SUSQUEHANNA STEAM ELECTRIC STATION SECOND SIX-MONTH STATUS REPORT IN RESPONSE TO MARCH 12, 2012 COMMISSION ORDER MODIFYING LICENSES WITH REGARD TO RELIABLE SPENT FUEL POOL INSTRUMENTATION (NRC ORDER EA-12-051) PLA-7138

PPL Susquehanna, LLC's Response to Request for Additional Information Regarding the Overall Integrated Plan for Implementation of Order EA-12-051, Reliable Spent Fuel Pool Instrumentation, dated November 6, 2013.

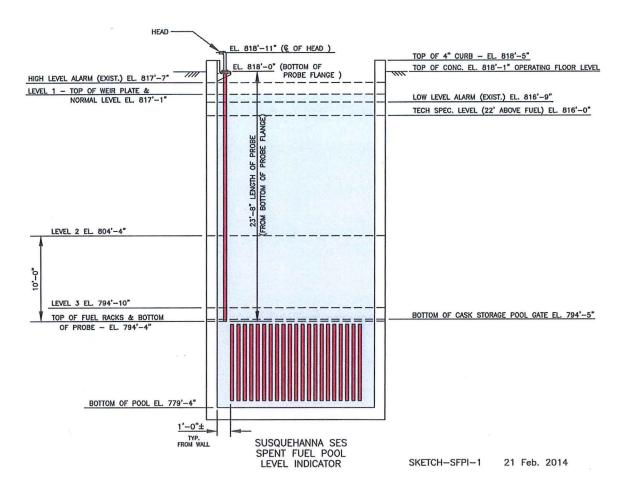
24	RAI-14.b – Please provide a description of the methodology that will be used for determining the maximum allowed deviation from the instrument channel design accuracy that will be employed under normal operating conditions as an acceptance criterion for a calibration procedure to flag to operators and to technicians that the channel requires adjustment to within the normal condition design accuracy.  Note - This information was previously requested as RAI-9.b in the NRC letter dated June 17, 2013.	14.b – The requested information does not currently exist and is being developed as part of our design process. The information will be provided as part of an upcoming required 6-month update to the Overall Integrated Plan, or as a separate transmittal, but is expected to be supplied no later than August 28, 2014.

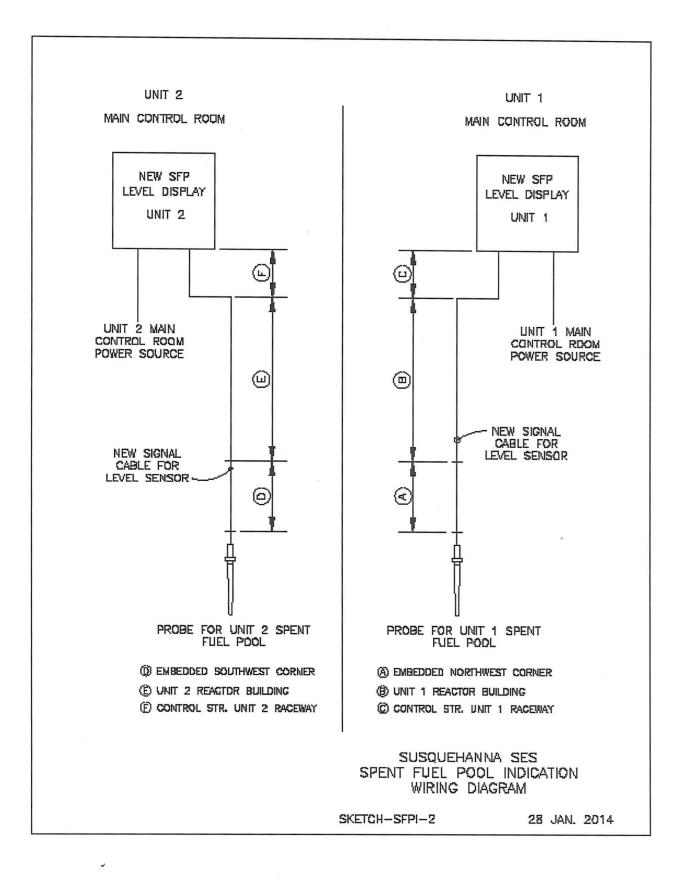
Item #	NRC RAI and enhanced identifiers	PPL Response
25	RAI-15.a — Please provide a description of the capability and provisions the proposed level sensing equipment will have to enable periodic testing and calibration, including how this capability enables the equipment to be tested in-situ.  Note - This information was previously requested as RAI-10.a in the NRC letter dated June 17, 2013.	15.a — The instrument automatically monitors the integrity of the installed level measurement system using built-in diagnostic capability. Periodic calibration checks of the signal processor electronics will be achieved through the use of standard measurement and test equipment.  The probe itself is a perforated tubular coaxial waveguide with defined geometry and need not be calibrated. It will be periodically visually inspected to demonstrate that the probe assembly has not experienced any mechanical deformation.  Each instrument electronically logs a record of measurement values over time in a non-volatile memory that can be compared to demonstrate constancy, including any changes in pool level, such as that associated with the normal evaporative loss/refilling cycle. The channel level measurements are able to be directly compared to each other (i.e., regular cross-channel comparisons) and existing SFP level instrumentation.

26	RAI-15.b — Please provide a description of how such testing and calibration will enable the conduct of regular channel checks of each independent channel against the other, and against any other permanently-installed SFP level instrumentation.  Note - This information was previously requested as RAI-10.b in the NRC letter dated June 17, 2013.	15.b – Each instrument electronically logs a record of measurement values over time in non-volatile memory that can be compared to demonstrate constancy, including any changes in pool level, such as that associated with the normal evaporative loss/refilling cycle. The channel level measurements can be directly compared to each other (i.e., regular cross-channel comparisons) and existing SFP level instrumentation.
